MPCP FEC issues: FEC_Overhead function

Jeff Mandin - PMC-Sierra
802.3av TF – New Orleans
January 2009

OLT control mux

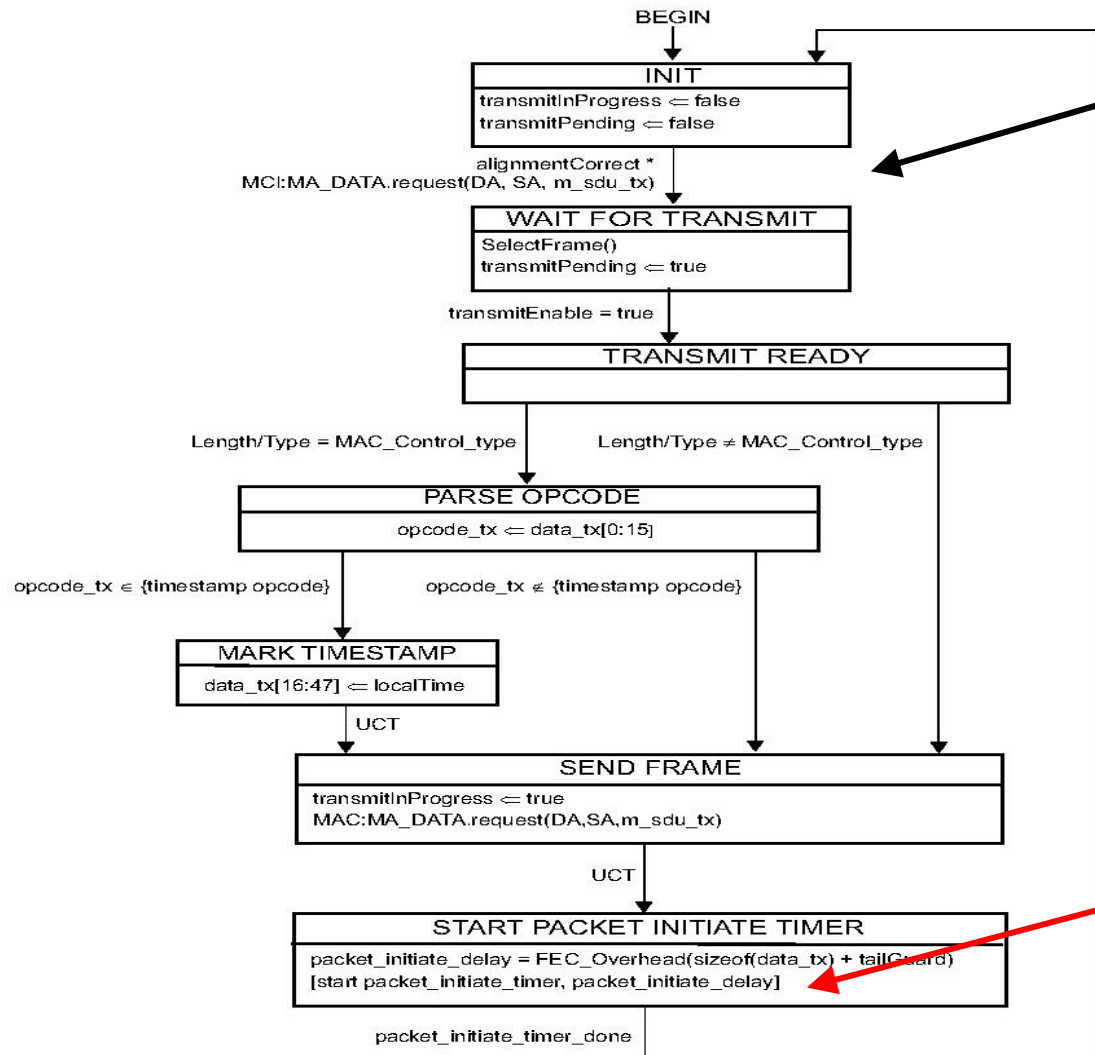
- The delay of transmit completion to the column (ie. 4-byte) boundary in *FEC_Overhead()* is not needed:
 - DIC is not active at end-of-frame
 - The check of alignmentCorrect (after *WaitForTransmit* state in the OLT and after *TransmitReady* state in the ONU) already guarantees that the next frame will be sent during the PCS data transmission phase (rather than PCS parity transmission phase)

2. If there is a real need for delay, it is done at this stage with alignmentCorrect – which ensures correct transmission each start of frame

1. Currently, there is delay to column boundary at end of frame

- Remedy:
 - a) Restore the definition of FEC_Overhead() from draft 2.1 ie.
 - $$\text{FEC_Overhead}(\text{length}) = [(\text{fecOffset}/\text{length})/\text{FEC_PAYLOAD_SIZE}] \times \text{FEC_PARITY_SIZE}$$

- a) Restore the invocations of FEC_Overhead() from draft 2.1 ie.
 - Change the first line in *Start Packet Initiate Timer State* in figures 77-13 and 77-14 to:

packet_initiate_delay = FEC_Overhead(sizeof(data_tx) + tailGuard) + sizeof(data_tx) + tailGuard
